House of Commons
Environmental Audit
Committee

**HS2 and the
environment**

Thirteenth Report of Session 2013–14

Figure 1: Offsetting metrics for habitats lost (left-hand side) and habitats gained (right-hand side)

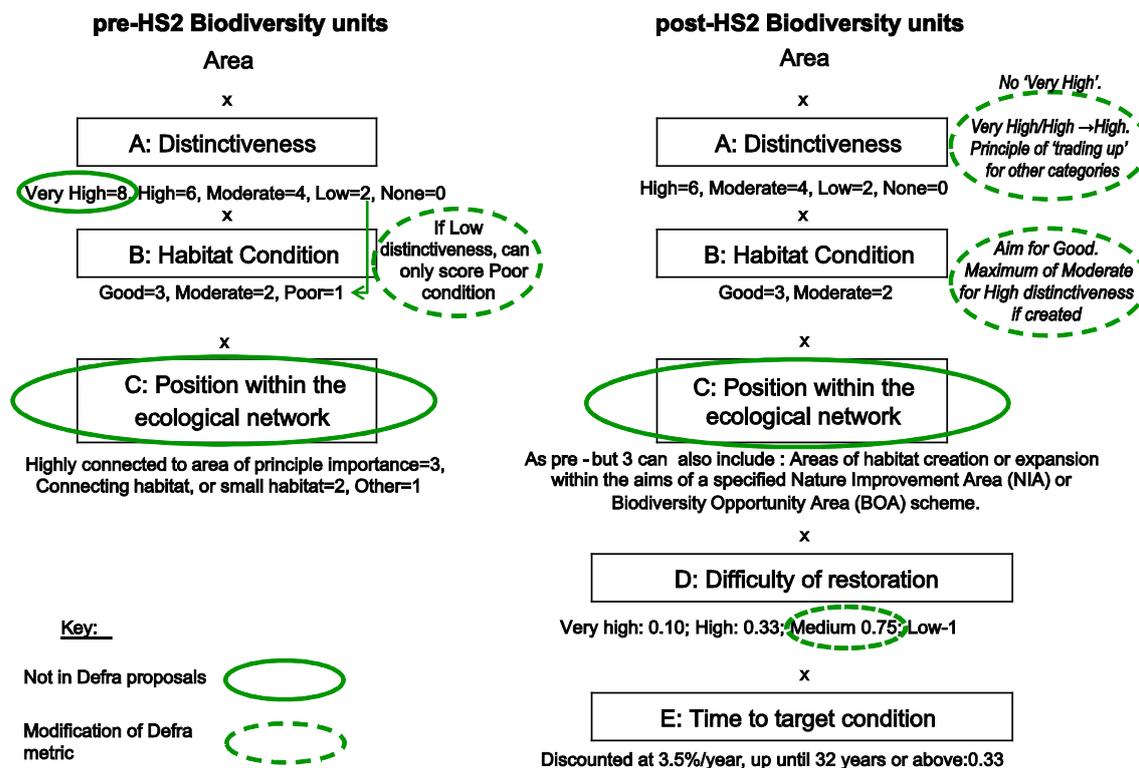
- i) adding an additional ‘very high’ weighting, under habitat distinctiveness (box A in Figure 1), for existing habitats to take account of those “habitats of principal importance ... which cannot be adequately re-created if lost”;
- ii) ensuring that all existing habitats rated as ‘low’ ‘distinctiveness’ automatically score ‘poor’ condition (box B in Figure 1), recognising that “condition has negligible effect on the overall value of those habitats which are intrinsically of low distinctiveness”; and
- iii) incorporating additional weightings, for both lost and gained habitats, to reflect links to ecological networks (box C in Figure 1) and recognising “the landscape-scale of the project and its impacts”.

restoration or enhancement is proposed then a habitat condition of ‘high’ can be targeted for habitats of ‘high’, ‘moderate’ or ‘low’ distinctiveness”.⁷¹ The assumption that “all habitats that are to be created for the primary purpose of ecological mitigation will aim to achieve the maximum target condition available (i.e. a score of 3 for habitats of moderate distinctiveness and 2 for habitats of high distinctiveness).” Replacement habitats will therefore not be provided if they would score as being in ‘poor’ condition⁷² (box B in Figure 1).

The proposed HS2 metric includes a multiplier for assessing the connectivity of the ecosystem (box C in Figure 1), but does not explicitly include any consideration of species within the metric. RSPB believed that “the [HS2] *Technical Note* should acknowledge the known weaknesses in the Defra offsetting metrics in dealing with impacts on species in general and specialist species in particular”, and concluded that the metric therefore “under-estimated the impacts on species of conservation concern”.⁷⁴

Environment Bank questioned whether a ‘distinctiveness’ weighting of eight (box A in Figure 1) “adequately reflect[ed] their biodiversity value”.⁸⁷ Robert Goodwill MP told us that such a weighting would mean that eight times the area of ancient woodland lost would have to be provided through offsetting land.⁸⁸ In fact the distinctiveness score of eight for ‘very high’ distinctiveness habitats would be only double the score (four) for ‘medium’ distinctiveness habitats. The area of offsetting required would depend on other factors (condition or ecological network links), as well as the difficulty of restoration and how long it would take (boxes D and E in Figure 1).

37. The HS2 metric makes assumptions about how long different types of offsetting habitats would need to reach ‘target condition’ (box E in Figure 1), including for example five years for ponds, 10 years for landscaping woodlands and 32 years for mature

Woodland (for ecological purposes) is recorded as 32 years+ which is probably appropriate, but ‘landscape’ woodland is said to reach target condition in only 10 years. At this age, however, such woodland will not be ecologically functional. ... Full habitat establishment of grassland is claimed within 5-10 years; we suggest it is unlikely that 5 years is sufficient and the use of this figure does not adhere to the precautionary principle.⁹¹

13. Given the uncertainties surrounding the effectiveness of offsetting on HS2, along with the scale of the land to be taken by the project, the [HS2 offsetting] metric should be adjusted wherever possible to encompass the precautionary principle. It should for example only allow offset land to be categorised as 'good' condition if there is a fully costed long-term plan for the site's management and independent monitoring. As Defra are still finalising the standard metric for offsetting, HS2 should look to incorporate any additional learning from these pilots into the metric for this project, to ensure it is robust and reflects best available information. (Paragraph 35)
